District Planning Scheme No.2 Amendment No.58

Figure 5.1.3 : Proposed Character Areas

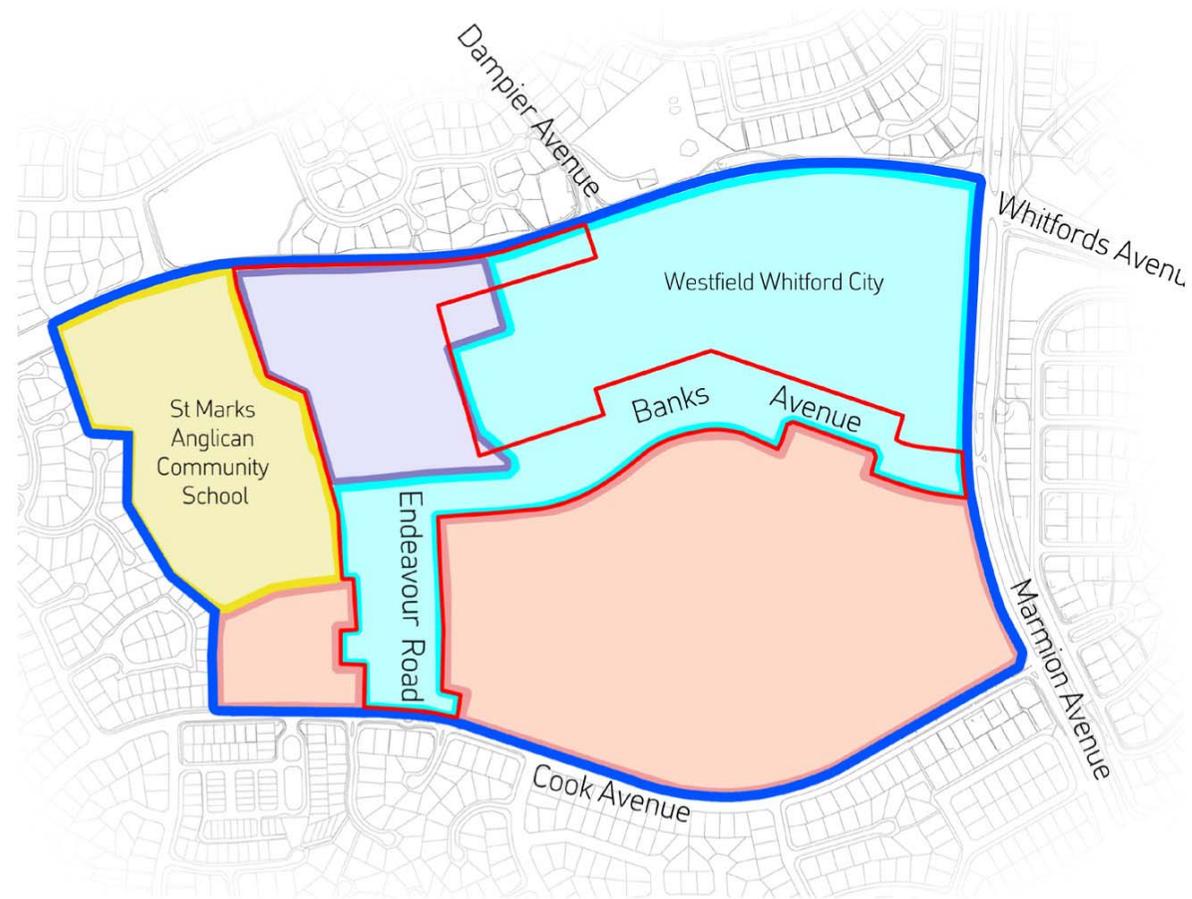
CHARACTER AREA		PROVISION	COMMENT ON STATUTORY PROVISIONS
CORE		<p>Building Height</p> <p>Tallest buildings close to the town square on Endeavour Road (12-14 storeys)</p> <p>Three storeys at the street, with podium levels setback from the street to provide solar access and appropriate scale.</p>	<p>Significant change from existing urban form, however the building heights may be required to achieve the 'Intensity' and 'Diversity' targets set out in the Activity Centre Policy.</p> <p>A proposed 15 storey development within the WAC area is significantly larger than any development currently planned for the Joondalup City Centre.</p> <p>It is anticipated that there may be a strong community reaction to the proposed building heights.</p> <p>Three storey street level development is considered appropriate.</p>
		<p>Building Typologies</p> <p>Sleeving to large format buildings.</p> <p>Podium apartments.</p> <p>Integrated buildings at street level (minimum 3 storey).</p> <p>Articulated facades, detailed finishes.</p>	<p>Inadequate information is provided to make an assessment against this statutory provision.</p> <p>Proposed building typologies consist of sound planning principles.</p>

<p>Setbacks</p> <p>1 metre street front set back.</p> <p>Nil to side and rear (except where vehicle access is required).</p> <p>Buildings over 3 storeys setback minimum 6 metres from street.</p>	<p>The draft structure plan includes the following rationale for a 1 metre setback:</p> <p><i>' a strict application of nil setbacks can have undesired effects of long unarticulated building edges as developers push for maximum floor space.'</i></p> <p>An average street setback of 1 metre is therefore supported as it will enable a portion of a building to be setback at nil or 2 metres, break up building bulk and create visual interest.</p> <p>Podium setback proposed are consistent with the provisions proposed for the Joondalup City Centre. This will further reduce the impact of building bulk, overshadow and wind tunnelling.</p>
		<p>Traffic Environment</p> <p>Share zones, low speeds</p>	<p>Careful consideration is required to be given to Endeavour Road as it can become congested at times in its current form. Shared traffic zones and low traffic speeds will require detailed planning and traffic studies to demonstrate how this can be achieved.</p>

<p>Pedestrian Environment</p> <p>Shared zone</p> <p>On road cycling</p>	<p>Provision of high quality pedestrian paths, crossings and on road cycling is supported in principle, however the statutory provisions do not adequately address responsibility for coordination and funding of these improvements.</p>
		<p>Parking</p> <p>On street parking.</p> <p>Parking decks sleeved.</p> <p>Maximum parking provisions apply.</p>	<p>On street parking along Endeavour Road may be limited due to sightline restrictions and access and egress points.</p> <p>Further clarification is required to determine the extent to which car parking area must be sleeved.</p> <p>The provision requires further clarification to ensure on street parking is provided in accordance with a future WAC Parking and Traffic Strategy.</p>
		<p>Land Use</p> <p>Uses not listed are not permitted unless at the discretion of the Council ('D' uses under clause 6.6 of the Scheme).</p> <ul style="list-style-type: none"> o Multiple Dwelling o Shop (up to 500 sqm) o Tavern o Restaurant o Consulting Rooms 	<p>Whilst the rationale for limiting shops to 500sqm is not provided, small scale retailing should be encouraged within main streets to provide maximum interest and activity. For this reason a maximum floor space for shops is supported.</p> <p>In addition to the permitted uses proposed, the following are considered appropriate for inclusion:</p> <ul style="list-style-type: none"> o Art Gallery o Beauty Parlour o Hairdresser

CHARACTER AREA	PROVISION		COMMENT ON STATUTORY PROVISIONS
		<ul style="list-style-type: none"> ○ Office 	<ul style="list-style-type: none"> ○ Medical Centre ○ Short Stay Accommodation ○ Small Bar ○ Single bedroom dwellings <p>In addition to the permitted uses proposed, the following are not considered appropriate within the Core (not permitted):</p> <ul style="list-style-type: none"> ○ Vehicle Panel Beating/Spray Painting ○ Vehicle Repair ○ Vehicle Sales and Hire ○ Vehicle Wrecking ○ Landscape supplies ○ Concrete Batching Plant ○ Fuel Depot ○ Abattoir
	Residential Density	<p>RAC 0</p> <p>70% of density target to be satisfied in core. Predominantly smaller dwellings and apartments.</p>	<p>The draft structure plan does not set out plot ratio or open space requirements for the RAC0 code. A 'Detail Site Plan' is required to provide greater guidance.</p> <p>It is therefore difficult to quantify what the RAC0 coding will result in.</p>

Resource Conservation	<p>PV arrays to taller buildings.</p> <p>Minimum 4.5 Star Green Star buildings.</p> <p>WSUD Principles.</p> <p>Sustainable strategies for energy, water, materials and waste</p>	<p>Inadequate information is provided to make an assessment against this statutory provision.</p> <p>It is noted that the Green Building Council of Australia strongly recommends that the Green Star Rating be used as a voluntary tool and not as a mandatory standard.</p> <p>For this reason, the mandated 'green' certification within the draft structure plan is not supported.</p> <p>As an alternative, incentives for certification should be provided.</p> <p>The use of PV arrays (central system in which PV panels are connected) may be useful in providing power to communal areas or services within a building. This could then offset strata costs. The use of PV arrays are encouraged, however more detail would be required if this was to be mandated (minimum size requirements etc)</p> <p>The draft structure plan notes that future sustainable strategies will be developed. The actions of these strategies may then become statutory provisions. Given that these strategies have not yet been developed, the suitability of mandating any related provisions are not known.</p>

CHARACTER AREA		PROVISION	COMMENT ON STATUTORY PROVISIONS	
RETAIL/MIXED USE FRAME		Building Height	Predominately 2 storeys with heights of up to 20 metres.	The proposed building height is not dramatically different to that currently on-site. Building height is considered appropriate.
		Building Typologies	Large format buildings.	Inadequate information is provided to make an assessment against this statutory provision. The proposed building typology is not dramatically different to that currently on-site.
		Setbacks	Determined by DSP's or council discretion.	Inadequate information is provided to make an assessment against this statutory provision. A 'Detail Site Plan' may be required to provide greater guidance. The responsibility for developing the DSP is unknown.
		Traffic Environment	Service routes and access points to be defined.	Inadequate information is provided to make an assessment against this statutory provision. Service routes and access points are likely to be defined within the future WAC Traffic and Parking Strategy.

Pedestrian Environment	Internal pedestrian malls connected to streets Secure cycle parking.	Proposed pedestrian connections are sound planning principles. Provision and location of secure cycle parking will be subject to the development of the WAC Parking Strategy.
		Parking	At grade parking, basements and sleeved decks.	Inadequate information is provided to make an assessment against this statutory provision. It is noted that parking within this character area will consist of at grade parking, basement parking and sleeved deck parking, but parking rates and location will be guided through the future parking strategy.
		Land Use	Uses not listed are not permitted unless at the discretion of the Council ('D' uses under clause 6.6 of the Scheme). <ul style="list-style-type: none"> o Department Store o Shop o Tavern o Restaurant o Consulting Rooms o Office o Showroom 	The site is currently zoned Commercial. As such, all uses currently permitted within this zone, should also be permitted in the draft structure plan. In addition to the permitted uses proposed, the following are considered appropriate for inclusion: <ul style="list-style-type: none"> o Cinema o Bank o Beauty Parlour o Art Gallery o Club (non residential) o Consulting rooms o Convenience store o Corner Store o Dry Cleaning Premises o Hairdresser o Hardware store o Home Business o Laundrette o Lunch Bar o Markets (retail) o Medical Centre o Reception Centre o Take away food outlet o Theatre o Veterinary Consulting Rooms o Short Stay Accommodation

CHARACTER AREA	PROVISION		COMMENT ON STATUTORY PROVISIONS
			<ul style="list-style-type: none"> ○ Small Bar ○ Single bedroom dwellings <p>In addition to the permitted uses proposed, the following are not considered appropriate within the Core (not permitted):</p> <ul style="list-style-type: none"> ○ Vehicle Panel Beating/Spray Painting ○ Vehicle Repair ○ Vehicle Sales and Hire ○ Vehicle Wrecking ○ Landscape supplies ○ Concrete Batching Plant ○ Fuel Depot ○ Abattoir
	Residential Density	RAC 0	<p>The Draft structure plan does not set out plot ratio or open space requirements for the RAC0 code. A 'Detail Site Plan' is required to provide greater guidance.</p> <p>It is therefore difficult to quantify what the RAC0 coding will result in.</p>
	Resource Conservation	<p>PV arrays to large format buildings.</p> <p>Minimum 4.5 Star Green Star buildings.</p> <p>WSUD Principles.</p> <p>Sustainable strategies for energy, water, materials and waste.</p>	<p>Inadequate information is provided to make an assessment against this statutory provision.</p> <p>As per the 'Core'</p>

CHARACTER AREA		PROVISION		COMMENT ON STATUTORY PROVISIONS
EDUCATION/ HEALTH/ COMMUNITY/ MIXED USE FRAME		Building Height	Up to 15 metres	The proposed building height would accommodate between 4 and 5 storeys. Landholdings in this location include a 'strata title' residential development and a School. Whilst redevelopment of these sites is unlikely, consideration would need to be given to the impact of this building height on the adjoining R20 residential interface.
		Building Typologies	Detached campus buildings in a landscape setting	Inadequate information is provided to make an assessment against this statutory provision. It is noted that there are a number of existing grouped dwellings in this location and that the building typology is not simply 'detached campus buildings in a landscape setting'.
		Setbacks	Determined by DSP's or council discretion.	Inadequate information is provided to make an assessment against this statutory provision. A 'Detail Site Plan' may be required to provide greater guidance. The responsibility for developing the DSP is unknown.

Traffic Environment	Shared zone, low speeds	The existing traffic environment (separated traffic and pedestrian space) work well is providing safe routes St Marks School. Modifying this road network to create a shared traffic space may not be appropriate statutory provision.
		Pedestrian Environment	Pedestrian priority. Secure cycle parking.	More information is required to understand what is meant by pedestrian priority and how this should be assessed. Provision and location of secure cycle parking will be subject to the development of the WAC Parking Strategy.
		Parking	Limit parking provision.	Inadequate information is provided to make an assessment against this statutory provision. Upper parking limits may be guided through the future parking strategy, however limiting parking provision within this precinct (eg. School site) may not be necessary.
		Land Use	Retail uses are not permitted and all other uses not listed are not permitted unless at the discretion of the Council ('D' uses under clause 6.6 of the Scheme). <ul style="list-style-type: none"> o Multiple Dwelling o Educational Establishment o Medical Centre o Nursing Home o Recreation Centre 	In addition to the permitted uses proposed, the following are considered appropriate for inclusion: <ul style="list-style-type: none"> o Bed and Breakfast o Consulting rooms o Home Business o Short Stay Accommodation o Single bedroom dwellings o Grouped dwelling In addition to the permitted uses proposed, the following are not considered appropriate within the Core (not permitted): <ul style="list-style-type: none"> o Vehicle Panel Beating/Spray Painting o Vehicle Repair o Vehicle Sales and Hire o Vehicle Wrecking o Landscape supplies o Concrete Batching Plant o Fuel Depot o Abattoir

CHARACTER AREA		PROVISION		COMMENT ON STATUTORY PROVISIONS
		Residential Density	RAC 0	<p>The Draft structure plan does not set out plot ratio or open space requirements for the RAC0 code. A 'Detail Site Plan' is required to provide greater guidance.</p> <p>It is therefore difficult to quantify what the RAC0 coding will result in.</p>
		Resource Conservation	<p>Minimum 4.5 Star Green Star buildings.</p> <p>WSUD Principles.</p> <p>Sustainable strategies for energy, water, materials and waste.</p>	<p>Inadequate information is provided to make an assessment against this statutory provision.</p> <p>As per the 'Core'</p>
ESSENTIAL FRAME		Building Height	Range of building heights up to 12 metres (3 to 4 storeys)	<p>The proposed building height may be appropriate for the purpose of achieving diversity and intensity targets.</p> <p>The shift from single storey to four storey development will change the character within this area. It will however provide an appropriate transition between the residential area south of Cook Avenue and development within the core of the WAC.</p> <p>Potential impacts of building bulk with the residential frame may be further managed through provision in a future Detailed Site Plan.</p>

Building Typologies	<p>Attached and detached dwellings.</p> <p>Opportunities for 'live work'.</p>	<p>Inadequate information is provided to make an assessment against this statutory provision.</p> <p>Proposed building typologies will provide opportunities for single houses, grouped dwellings, terrace housing, single bedroom dwellings and multiple dwellings.</p> <p>Increased opportunities for 'live work' scenarios are supported.</p> <p>Building typologies with the residential frame may be further managed through provision in a future Detailed Site Plan.</p>
		Setbacks	Residential Design Codes apply.	<p>The application of the RAC 0 code requires setbacks for multiple dwellings to be established in a Draft structure plan or Detail Site Plan. No setback requirement is proposed.</p> <p>Street setbacks for single houses or grouped dwellings would be 4 metres in accordance with the Residential Design Codes.</p>
